**MONTICELLO NUCLEAR GENERATING PLANT**  
Docket No. 50-263 License No. DPR-22

License Amendment Request  
Revised Pressure and Temperature Curves

License Amendment Request  
Revised Pressure and Temperature Curves

Figure 3.6.4 Minimum Temperature vs. Pressure for Critical Core Operation

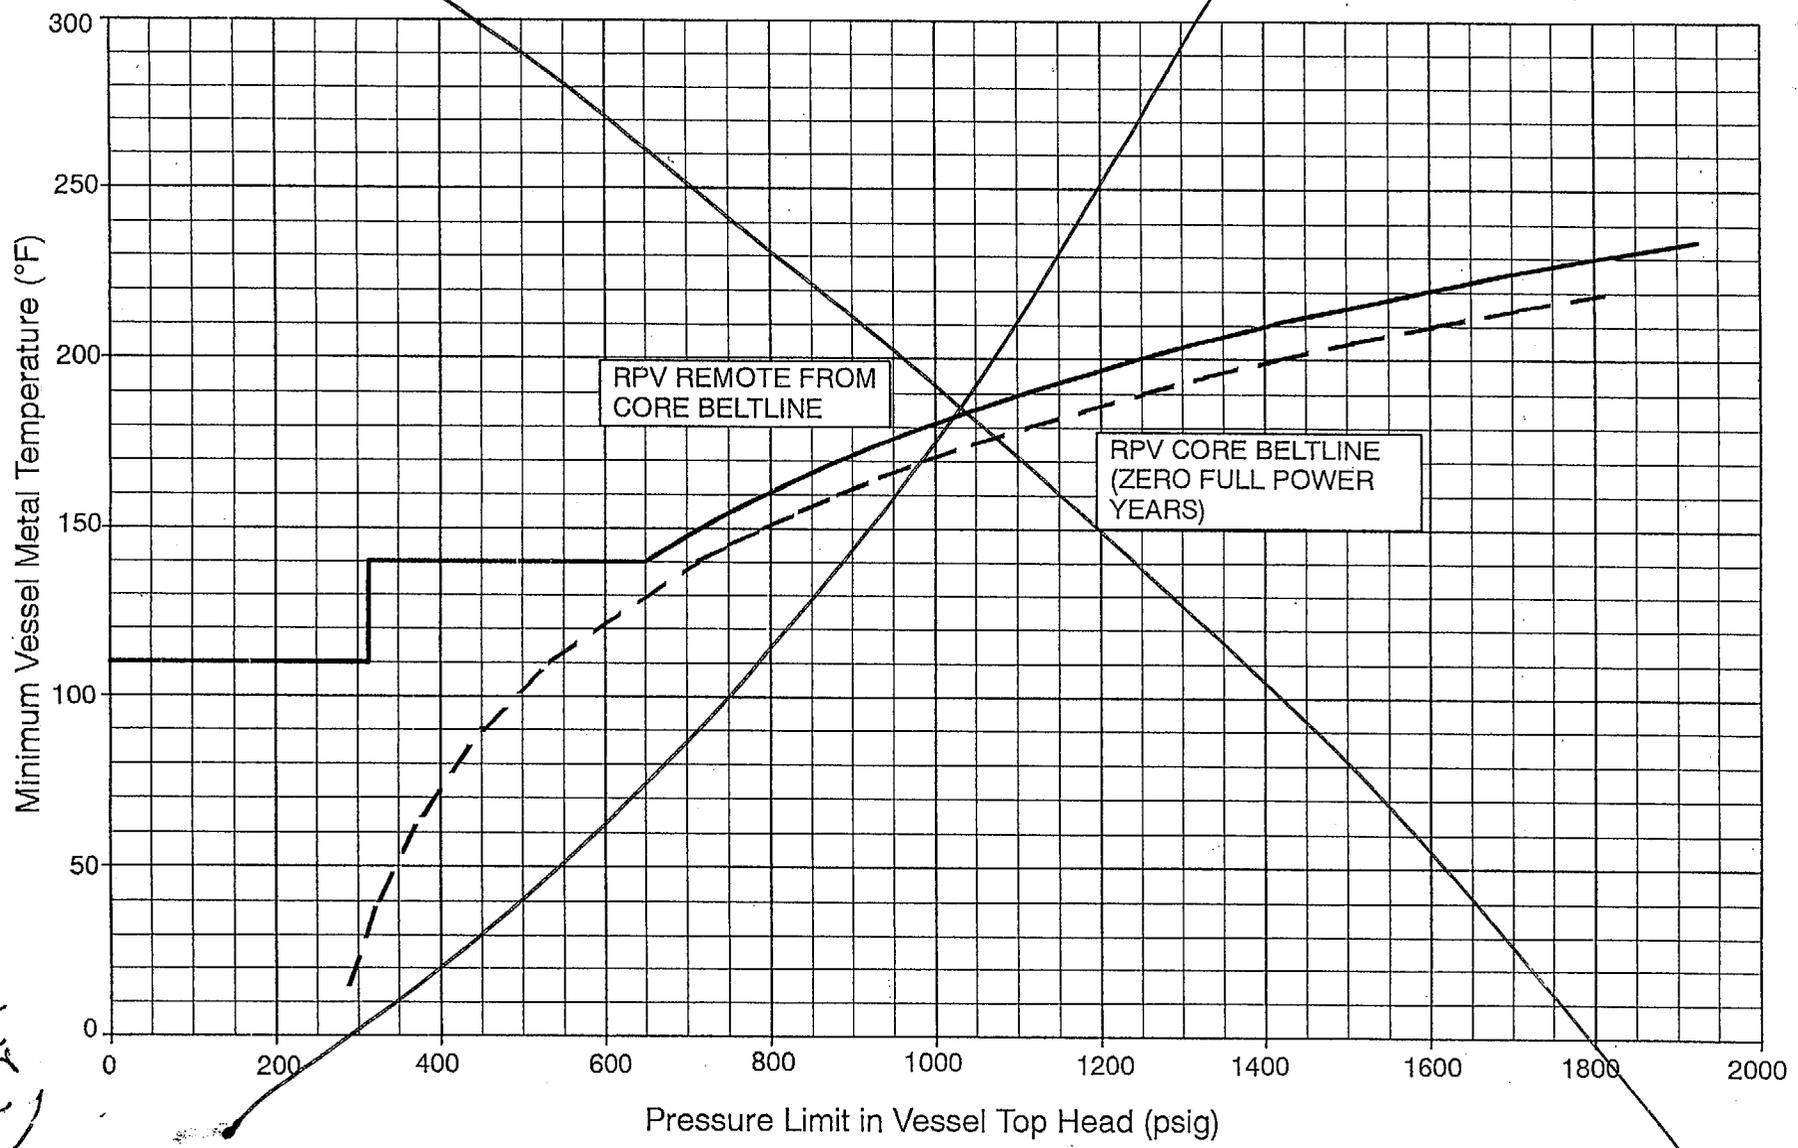
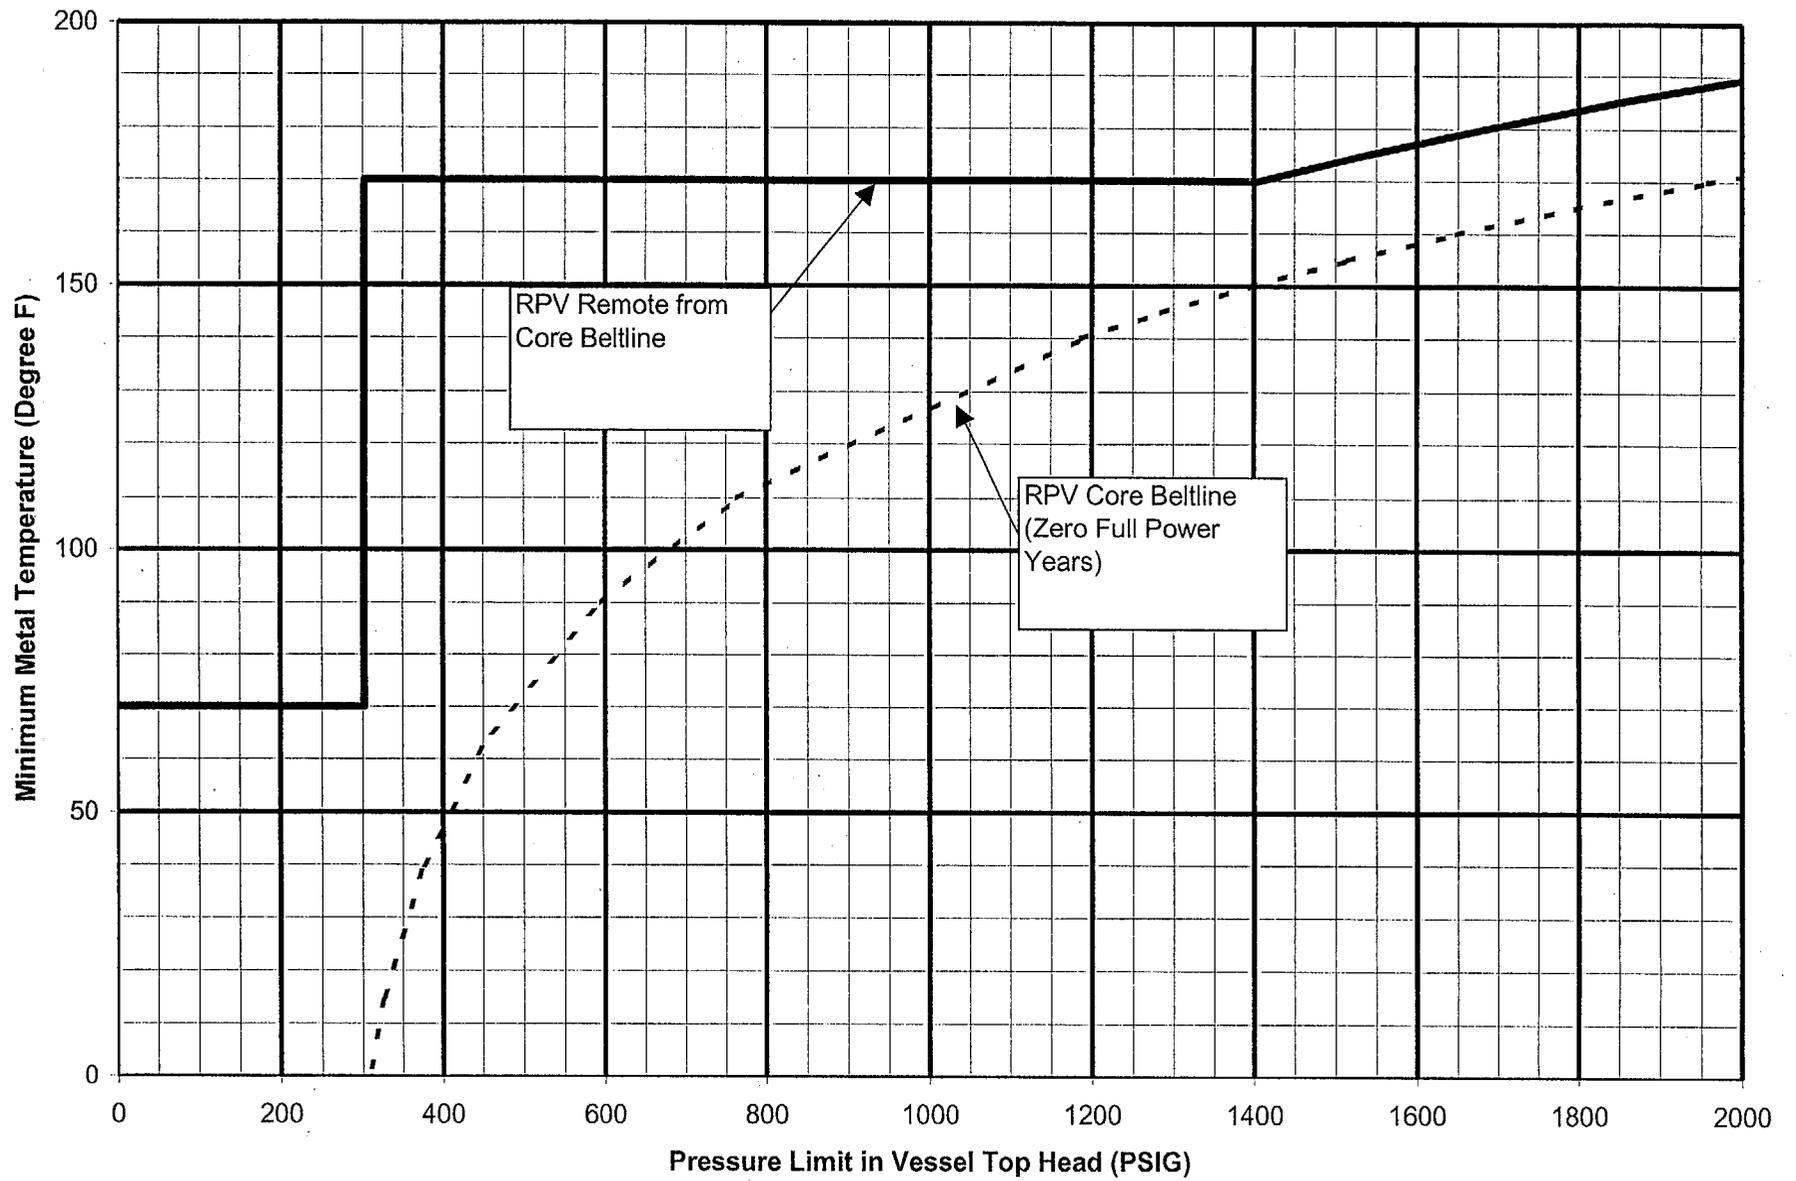
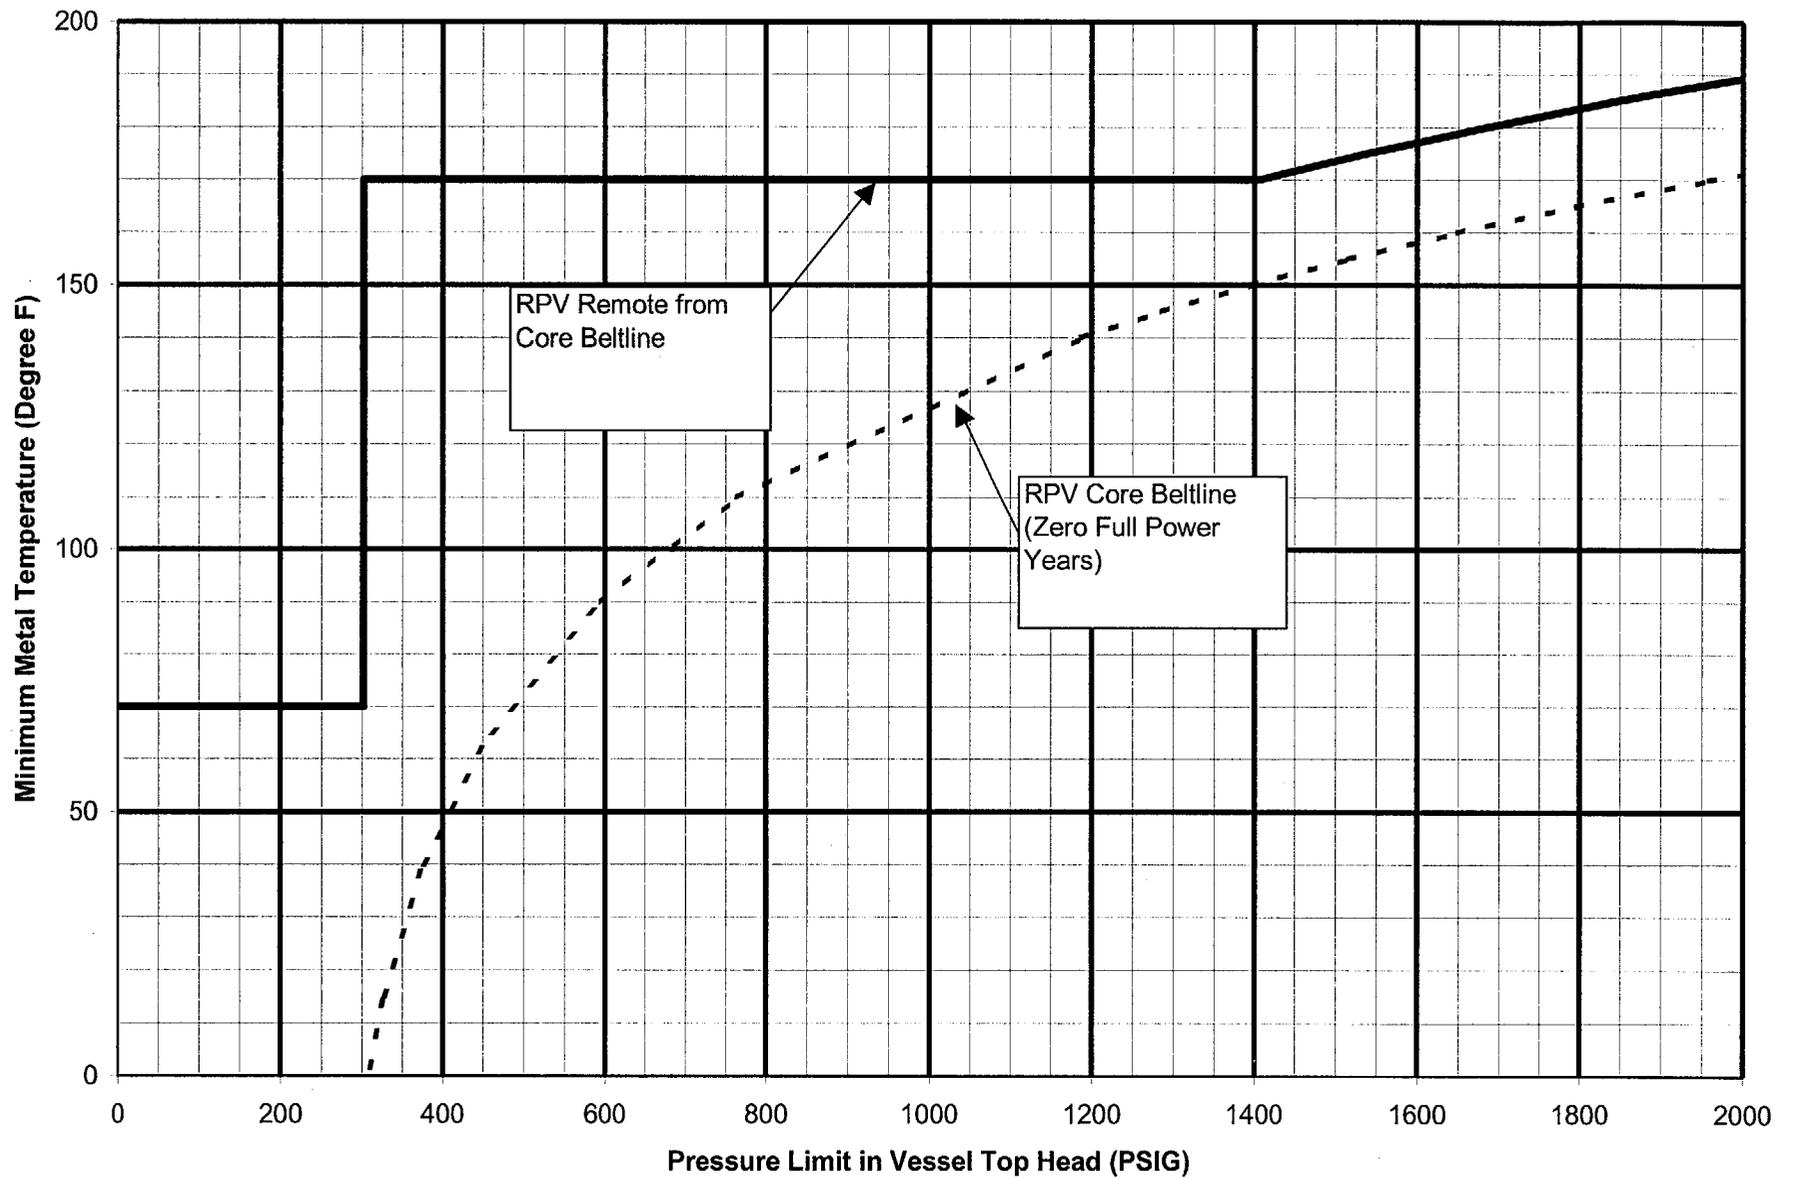
NMC proposes to revise the Monticello TS requirements for reactor pressure vessel (RPV) P/T limit curves. Changes are proposed to Monticello TS Figures 3.6.2, 3.6.3 and 3.6.4 which show the P/T limit curves for inservice leakage and hydrostatic testing, non-nuclear heatup and cooldown, and criticality. No changes to the Limiting Conditions for Operation or any Surveillance Requirements of Technical Specification 3.6.B are proposed.

INSERT ATTACHED
